**Transmission Symptom - Transmission Oil Leaks Out When Driving on Race Circuits:
Replacing Vent Line for Clutch Chamber (SY 130/19)**

Revision: This bulletin replaces bulletin Group 3 130/19, dated Mar 30, 2020. Update of APOS.

Vehicle Types: **911 GT3 (991)/911 GT3 RS (991)**

Subject: **Vent line for clutch chamber**

Vent line for clutch chamber

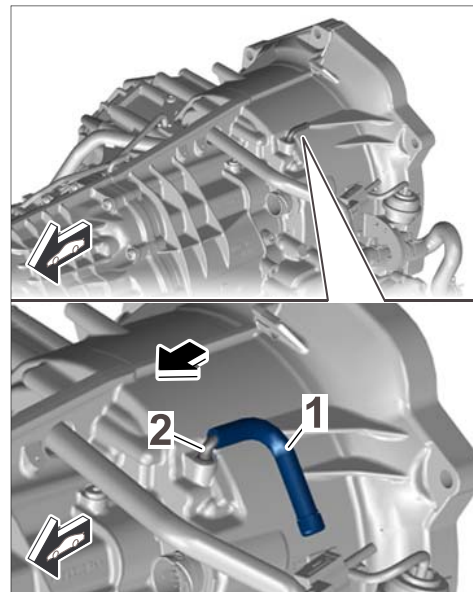
Work Procedure: 1 Disconnect vent line for clutch chamber ⇒ *Vent line for clutch chamber -1-* from breather pipe ⇒ *Vent line for clutch chamber -2-*.

New vent line for clutch chamber

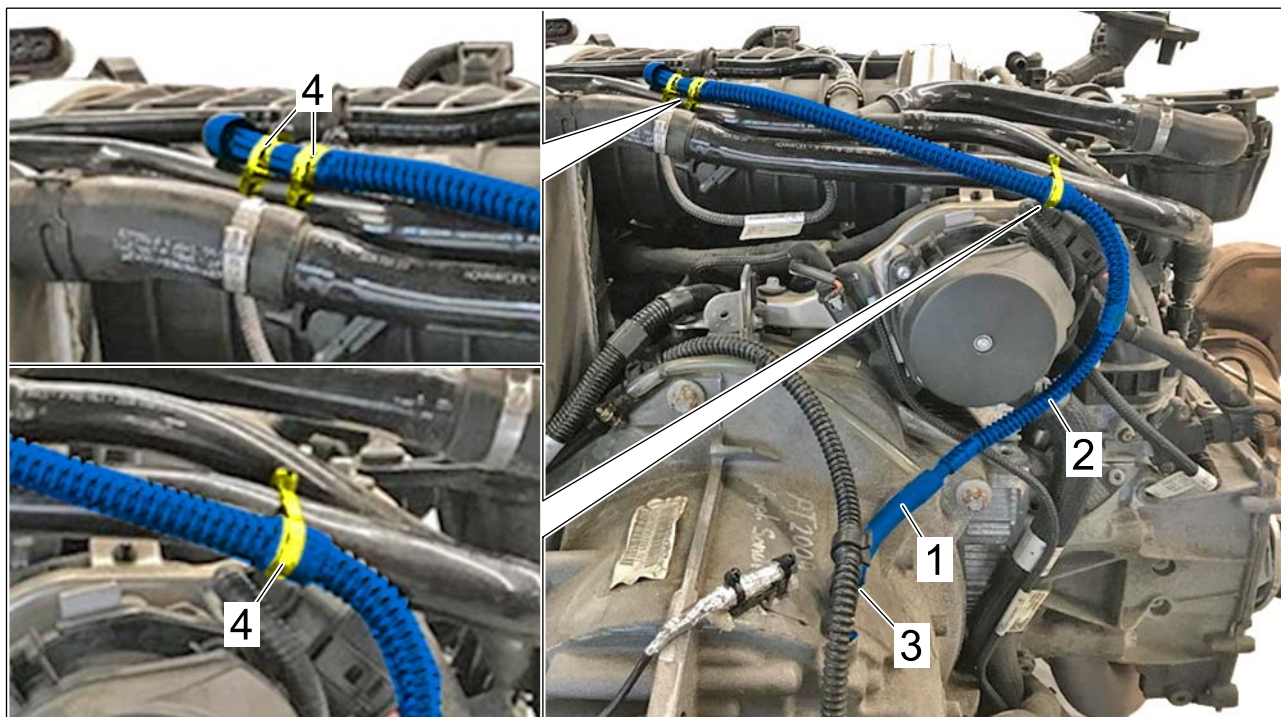
Symptom: Transmission oil leaks out of the vent line for the clutch chamber when driving on race circuits.

Cause: Highly dynamic driving on race circuits at high engine speeds causes oil foaming and can result in an oil leak from the PDK vent line on the clutch side in some cases.

2.1 Install **new** hose adapter (9GT301280) ⇒ *New vent line for clutch chamber -1-* on **new** vent line for clutch chamber (9GT301063) ⇒ *New vent line for clutch chamber -2-* and breather pipe ⇒ *New vent line for clutch chamber -3-*.

2.2 Route **new** vent line for clutch chamber (9GT301063) ⇒ *New vent line for clutch chamber -2-* so that it is routed continuously upwards as shown and secure with combination holders at positions ⇒ *New vent line for clutch chamber -4-*.
